RE: Williams Creek Drain, Springmill Road – 131<sup>st</sup> Street to Williams Creek Reconstruction

PETITION FOR RELOCATION AND RECONSTRUCTION

Re: Williams Creek Drain: Springmill Rd – 131<sup>st</sup> to Williams Creek Reconstruction

<table><tr> <td>HORIZONTAL SCALE</td> <td>BRIDGE FILE</td> </tr><tr> <td>-</td> <td>49 of 200</td> </tr></table>

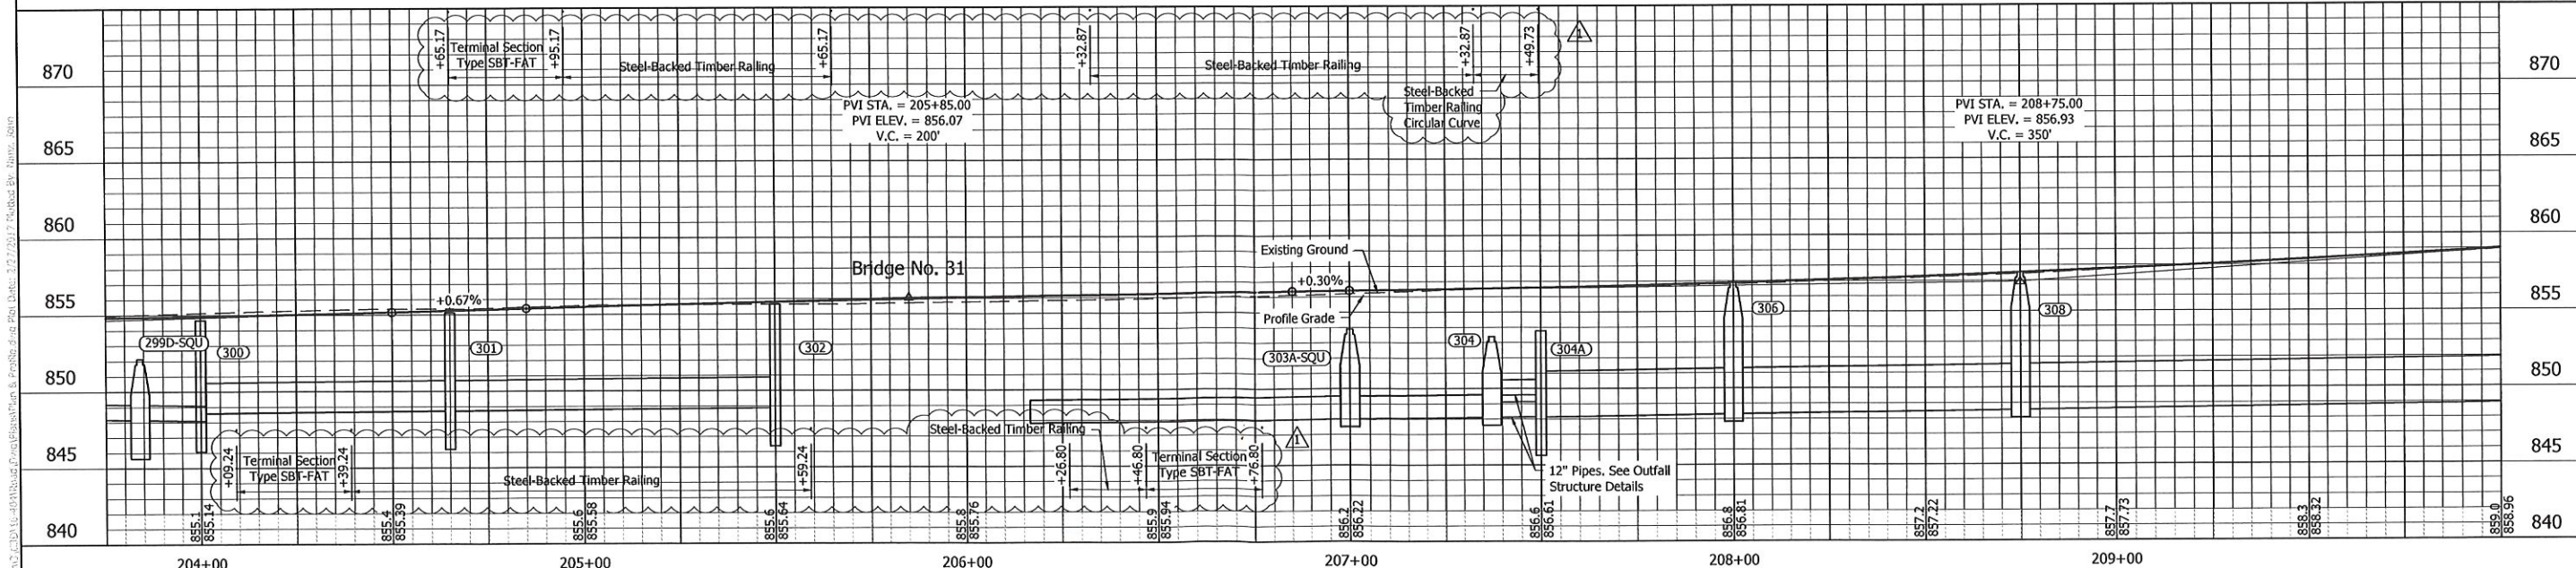
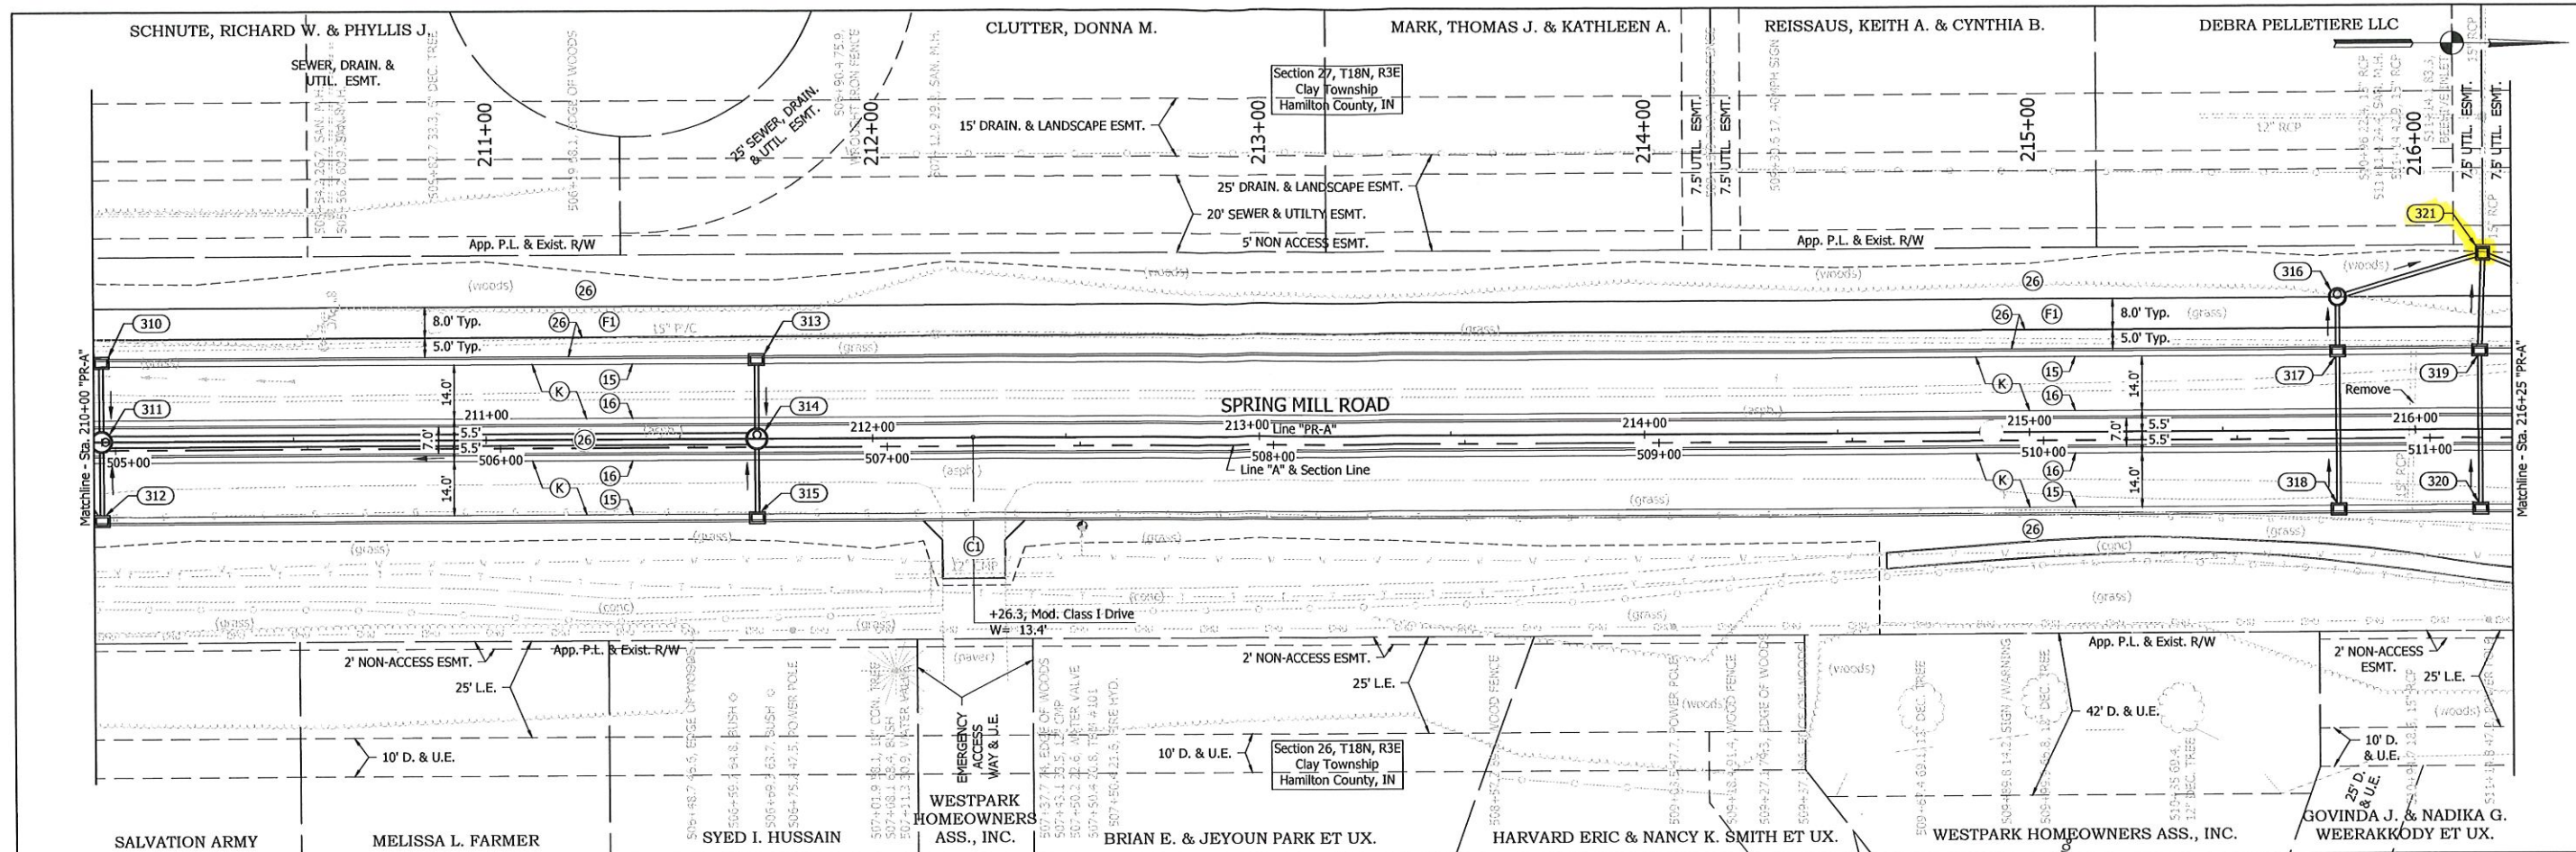
Williams Creek – Main Channel: With this project, 140 feet of open ditch, which is the main Williams Creek channel, from the west right of way line to the east right of way line of Springmill Road at Bridge Str. 31, will be added to the Williams Creek Regulated Drain. This is shown on Sheet 49 of the plans prepared by United Consulting, having City of Carmel Project Number 16-ENG-52, dated August 16, 2016.

<table><tr> <td>HORIZONTAL SCALE</td> <td>BRIDGE FILE</td> </tr><tr> <td>-</td> <td>52 of 200</td> </tr></table>

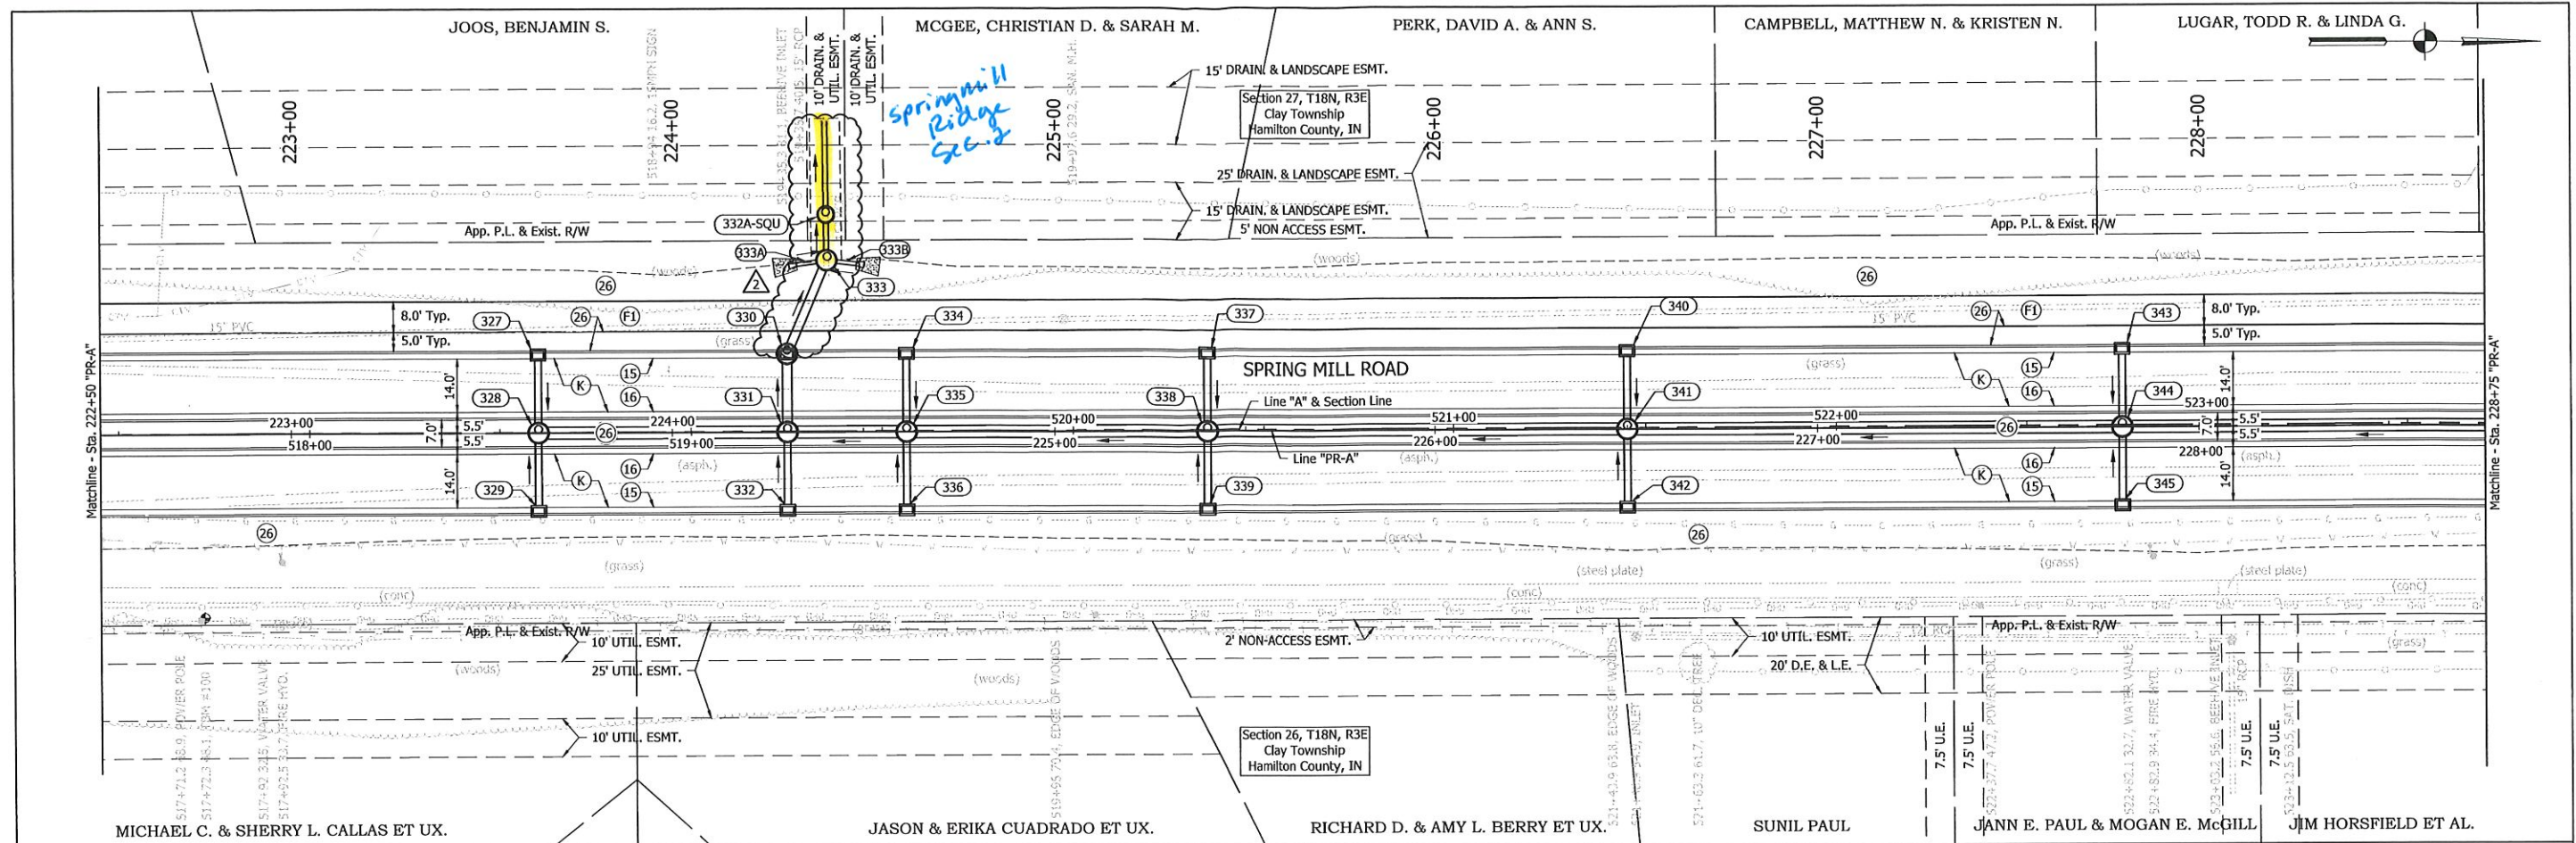
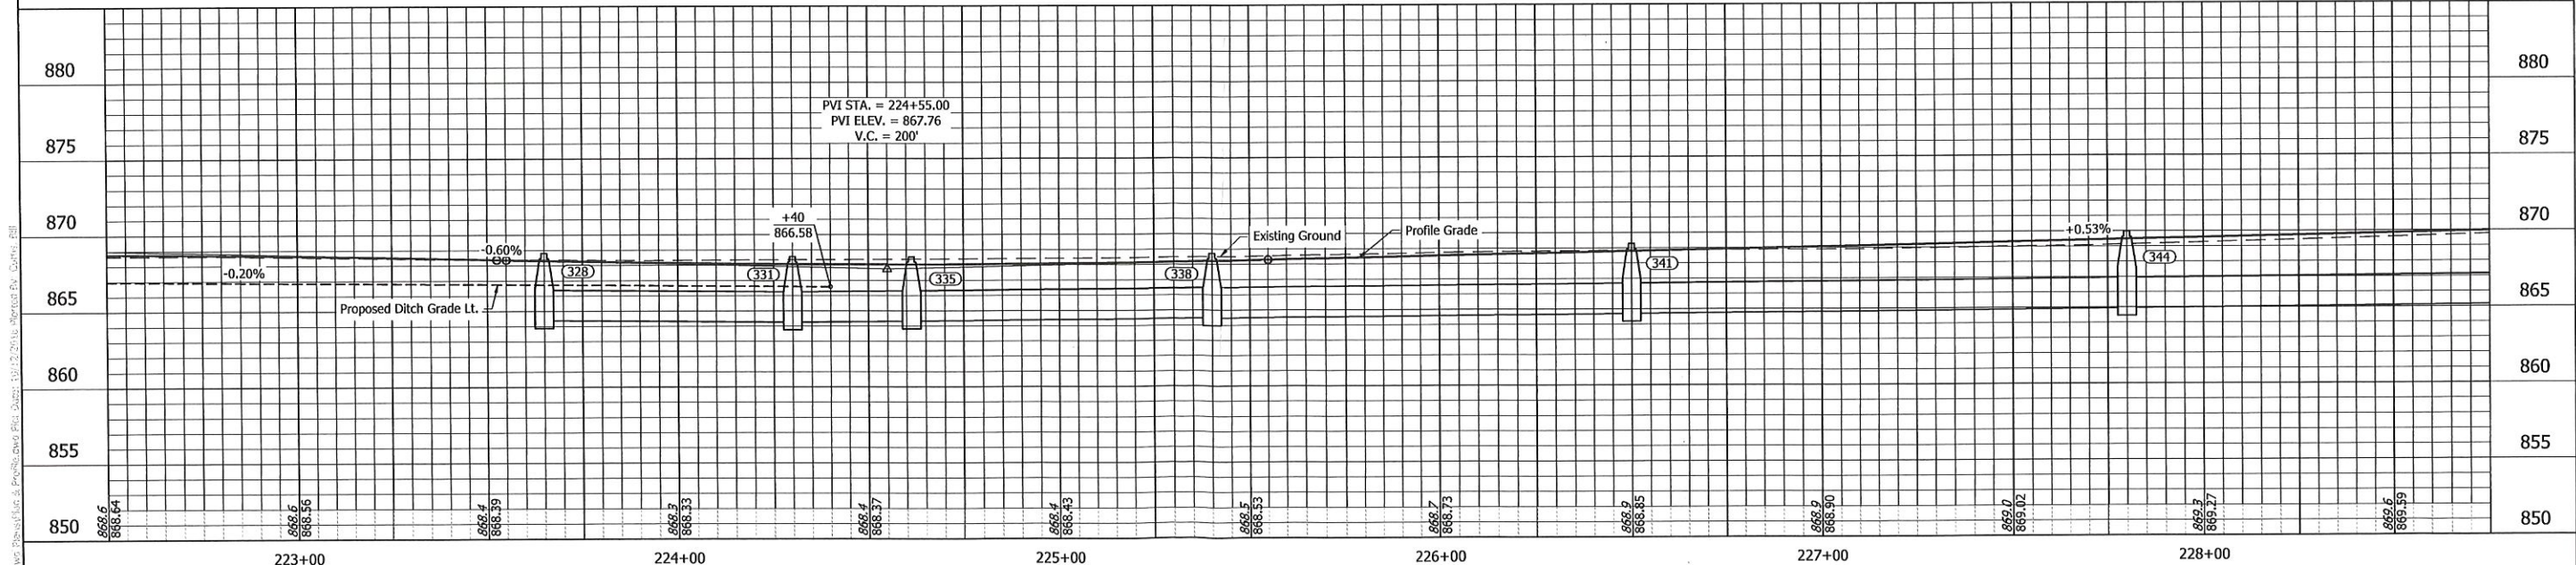
Williams Creek Drain – Springmill Ridge Section 2 Arm: The project will remove 38 feet of 15” RCP between Str. 628 and the end section (Str. 629), per the original plans. Thus, 38 feet of drain will be removed from the Williams Creek Drain – Springmill Ridge Section 2 Arm. This is shown on Sheet 52 of the plans prepared by United Consulting, having City of Carmel Project Number 16-ENG-52, dated August 16, 2016.
